## Field Safety Notice

Reference: R546

This voluntary Field Safety Notice (FSN) is to inform you about a Field Safety Corrective Action (FSCA) for the AR-9800 Synergy RF Console.

| Product Name                                                                         | Part No.       | Affected devices                      |
|--------------------------------------------------------------------------------------|----------------|---------------------------------------|
| <b>SYNERGY<sup>RF</sup> CONSOLE</b>                                                  | <b>AR-9800</b> | <b>All devices at Rev. 6 or below</b> |

New label

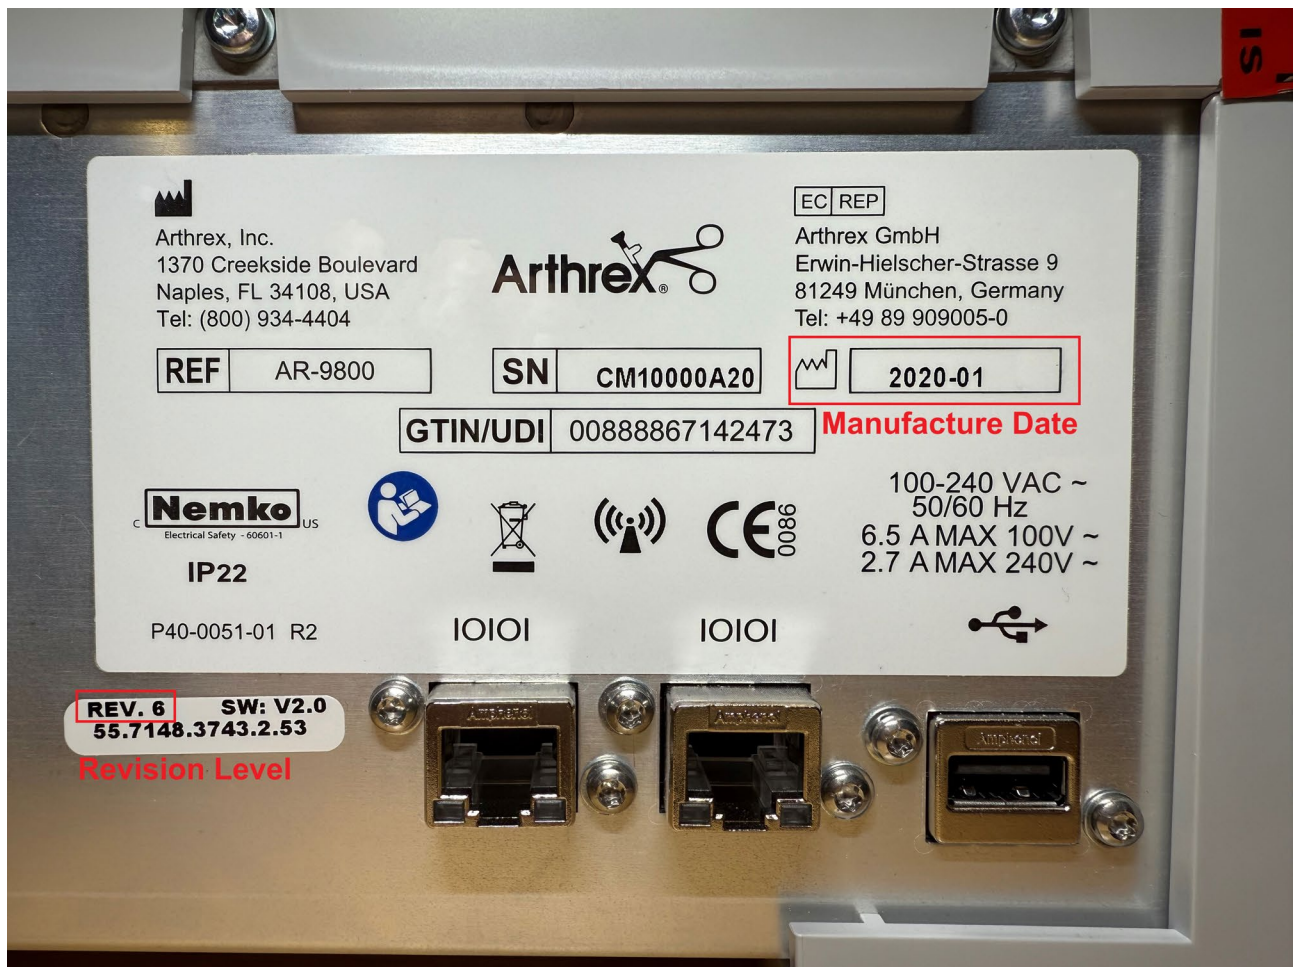
Upon initial power up of the AR-9800 there is a potential, with some electrical services, that an inrush current may occur. If this inrush current is to occur, there is a possibility that the circuit breaker trips. If the breaker trips, resetting the circuit breaker will be required to restore power. Other devices connected to the same electrical circuit would experience a temporary power outage until the circuit breaker is reset or the devices are connected to another power circuit.

Arthrex has identified 77 occurrences of complaints reporting breakers tripping for devices at Rev. 6 or below. The reported events have never resulted in harm to patients, users or third parties. Although no harm has been reported, it was determined that if a failure occurs, the worst potential outcome would be a failure to complete a procedure.

1. Immediately identify the indicated AR-9800 you have in your control.  
The affected devices can be identified via a label on the back of the device that indicates the revision level (see picture below). If the revision level label is not present, the device should be considered affected if the manufacturing date is prior to July 2020. The manufacturing date is indicated on the main label on the back of the device.

To resolve this issue, an Arthrex employee will replace the current T8A fuses with new F4A fuses and relabel the device with new fuse specifications.
